MIL-M-28787/184B
AMENDMENT 1
16 December 1992

MODULES, STANDARD ELECTRONIC

AMPLIFIER, POWER, ANALOG, KEY CODE SES

FIGURE 9. Stress (V_s), output short circuit current, accuracy, open circuit oscillation, absolute gain, and phase angle test circuit for tables V, VI, VII, and VIII.

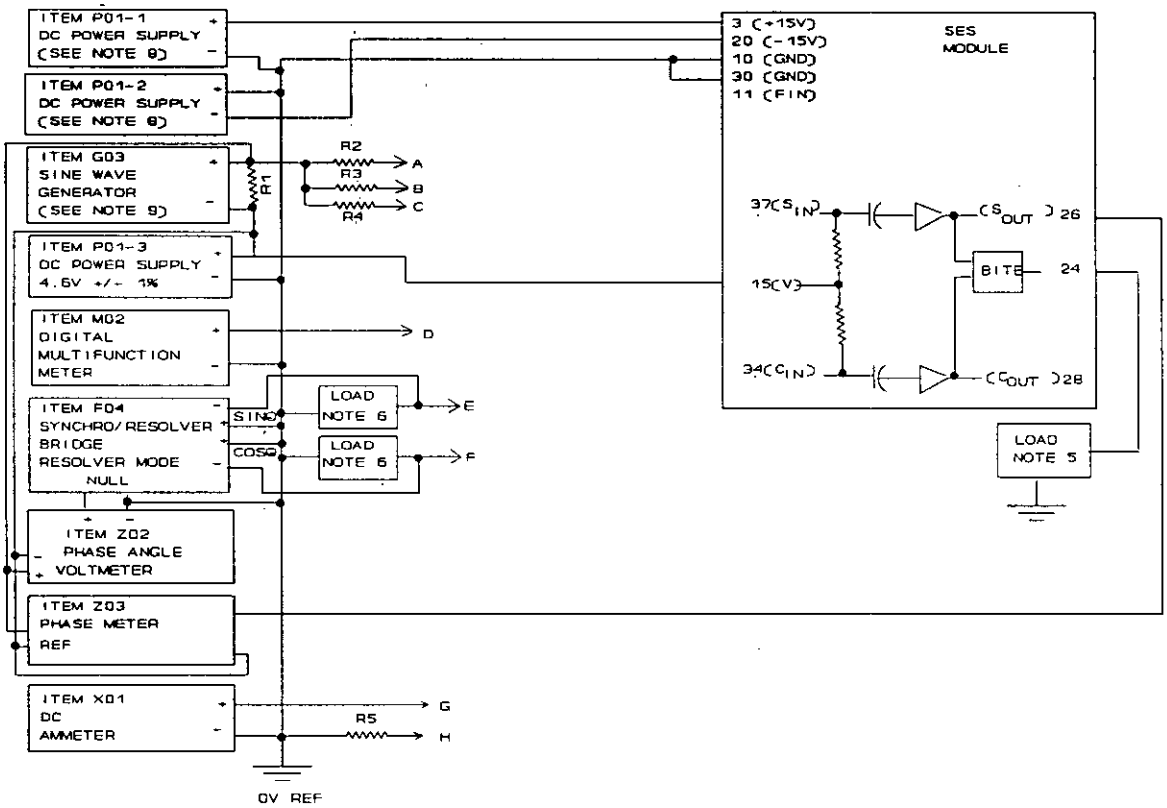
FIGURE 9: Delete and substitute new figure 9 as printed on page 2 of this amendment.

CAUTION:
Do not isolate the chassis of ammeter X01 from earth ground.
